DEVELOPMENT REVIEW COMMITTEE (DRC) COMMENT REPORT

PROJECT NAME: 650 N Andrews

CASE NUMBER: UDP-S23057

REQUEST: Site Plan Level II Review: Mixed Use Development
Consisting of 257 Multifamily Units and 11,400 Square-
Feet of Commercial Use in the Downtown Regional
Activity Center

Character Area (Applicable Area: Urban Neighborhood)

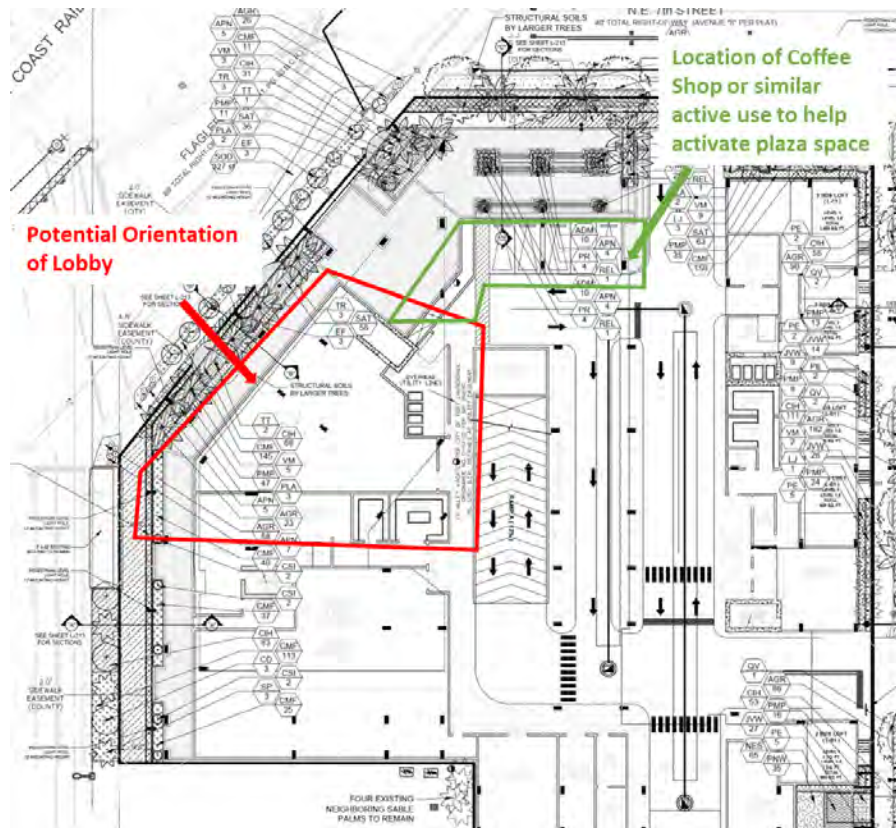
- s. 3C – A City Commission deviation request is required for tower stepback on Flagler Avenue and NE 7th Street.

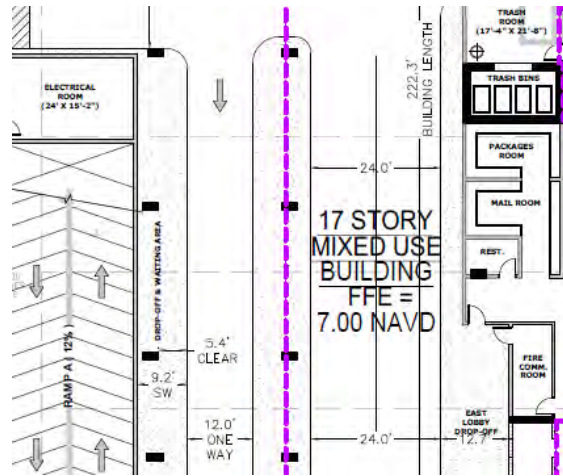
- d. The first floor commercial uses only show access internally. Provide additional right-of-way access to first floor commercial bays.
- e. The northern plaza needs to be better integrated with activated ground floor uses. The current orientation has the potential of becoming unused dead space because of its positioning between the driveway, abutting horizontal parking garage wall, and angular positioning to the first floor commercial spaces. Orientate the first floor lobby towards the natural focal point of the site, on the corner of Flagler Drive and North Andrews Avenue and integrate the plaza so visibility and use of the plaza space is less isolated.

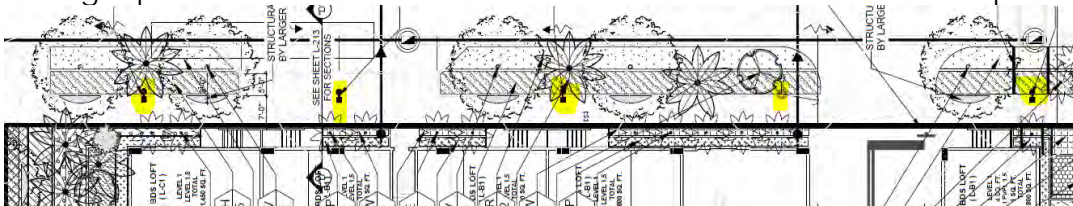
- f. Consider parking higher intensity uses such as restaurants to increase flexibility of commercial bays such as the inclusion of a bar, restaurant, coffee shop that incorporates outdoor seating and activation of the plaza and arcade.
- g. Provide floor plans for all levels of parking. Currently floor plans show the mezzanine floors, but do not show all the parking level floor plans.
- h. Update label on the site plan which states "17 Story Mixed-use Building".

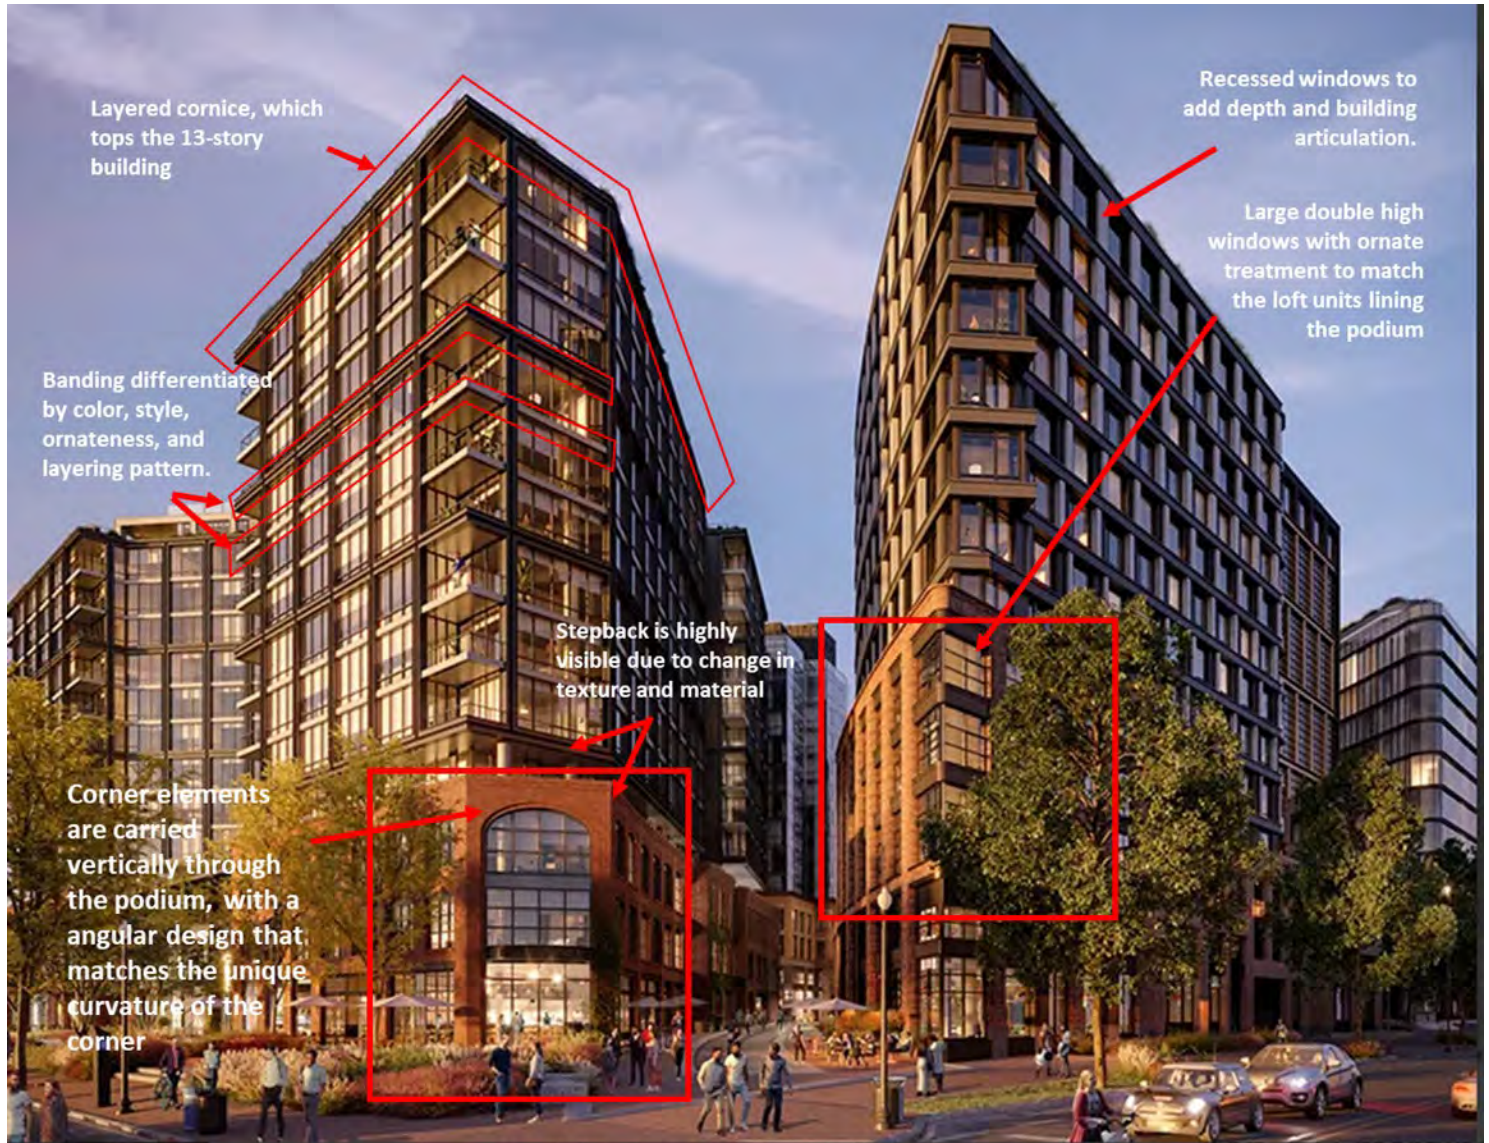
- e. The materials of rooftop mechanical rooms must match the materials of the principal structure.
- f. Provide a material change to the corner of the western tower running vertically from the base of the building to the top of the podium and increase the projection of the corner units (or increase the recession that's currently provided) to place a visual emphasis on the northwest corner. Additionally, wrap the floor to ceiling windows at the corner along the frontage of North Andrews to create a larger primary focal point.

g. An alternative design is needed in lieu of the 11 story murals such as windows and balconies. Murals are not intended to replace facade design features.
